Access Compliance Report

Public Rights-of-Way

Intersection ID: 11963	Main Street: S_GRAHAM_ST	Cross Street: W_4TH_ST	Location: N
ADA ID: DE16FEA36253	Ramp Type: Perp	Initial Pass/Fail: Fail	Overall Compliance: No
Severity Score: 13.75			
Codes/Mitigation Info/Possible Solution		Field Measurements/Component Compliance

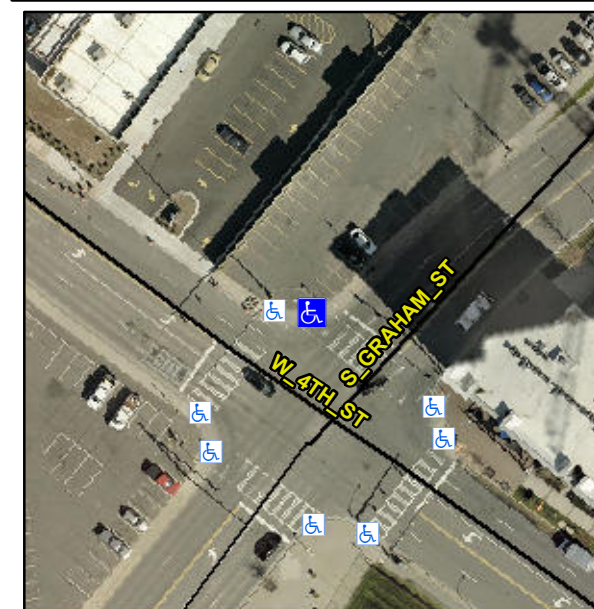
R304.2.2, R304.5.3

Compliance	Description	Data	Compliance	Description	Data
N/A	Ramp Length (in)	73.0	No	Ramp Slope (%)	8.8
Yes	Ramp Width (in)	48.0	No	Ramp XSlope (%)	3.3
N/A	Flare Type LT	N/A	N/A	Flare Type RT	N/A
N/A	Flare Slope LT (%)	N/A	N/A	Flare Slope RT (%)	N/A
N/A	Flare Traversable LT?	N/A	N/A	Flare Traversable RT?	N/A
N/A	Landing Length (in)	N/A	N/A	DWS Provided?	N/A
N/A	Landing Width (in)	N/A	N/A	DWS Contrast?	N/A
N/A	Landing Slope (%)	N/A	N/A	DWS Length (in)	N/A
N/A	Landing X Slope (%)	N/A	N/A	DWS Full Width?	N/A
N/A	Landing Curb? (Y/N)	N/A	N/A	DWS Offset (in)	N/A
N/A	Shared Landing?	N/A			
N/A	Gutter Ponding?	N/A	N/A	Gutter Slope (%)	N/A
N/A	Gutter Lip Ht (in)	N/A	N/A	Gutter X Slope (%)	N/A
N/A	Painted X Walk1?	Yes	N/A	Painted X Walk2?	N/A
	X Walk 1 Direction	To SE		X Walk 2 Direction	N/A
N/A	X Walk 1 Width (in)	175.0	N/A	X Walk 2 Width (in)	N/A
	X Walk 1 Slope (%)	6.1		X Walk 2 Slope (%)	N/A
	X Walk 1 X Slope (%)	2.3		X Walk 2 X Slope (%)	N/A

Remove & Replace Entire Ramp.
